Delegated officer report for planning application

Application no. 144144/FO/2025
Date registered valid: 30 September 2025
Proposal: Installation of digital LED totem.
Address: Outside No. 9 Stevenson Square, Manchester, M1 1DB
Ward(s): Piccadilly Ward

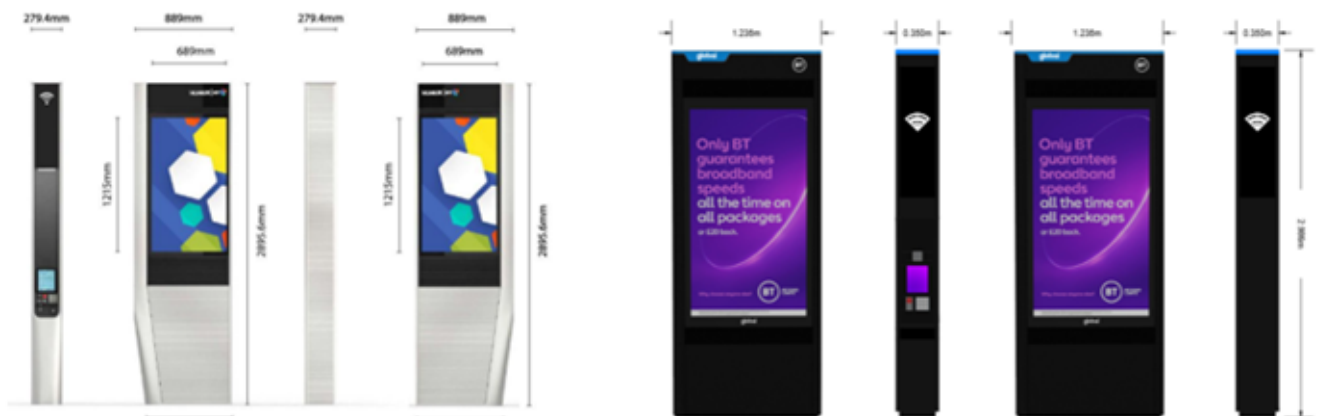
The approval of the existing LED totem on site, approved under planning permission 121598/FO/2018, formed part of a wider strategy to declutter the City Centre's footways of redundant telephone boxes. As shown by the photographs above, the street scene surrounding the application site is a well trafficked and landscaped area of public pavement that contributes positively to the setting of the Conservation Area and neighbouring listed buildings.
